MELTON PLANNING SCHEME

This document is an incorporated document in the Schedule to Clause ~~45.12~~ ~~51.01~~ ~~52.03~~ and the Schedule to Clause ~~72.04~~ ~~84.04~~ of the Melton Planning Scheme (the Scheme).

APPENDIX 1 – SITE PLAN

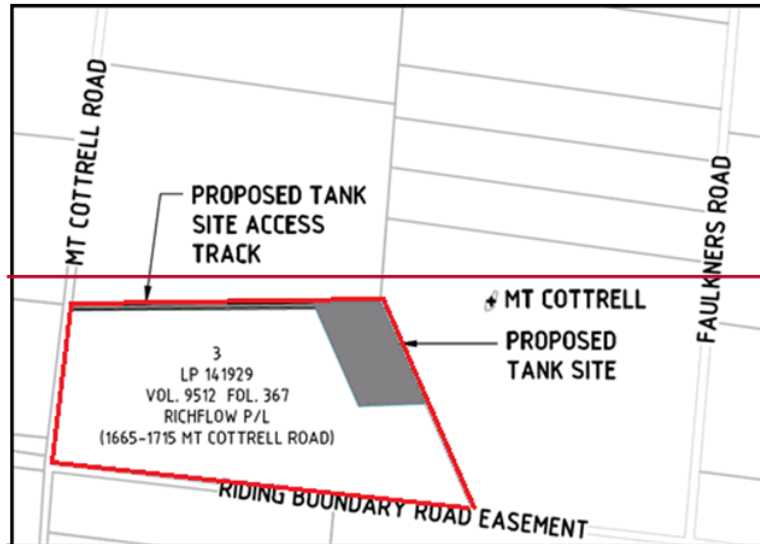
This incorporated document applies to the ~~grey area within the red box~~ hatched land.

This ~~grey area~~ hatched land will be known as a 'reserve' for the purpose of a '~~recycled~~ water storage facility'.
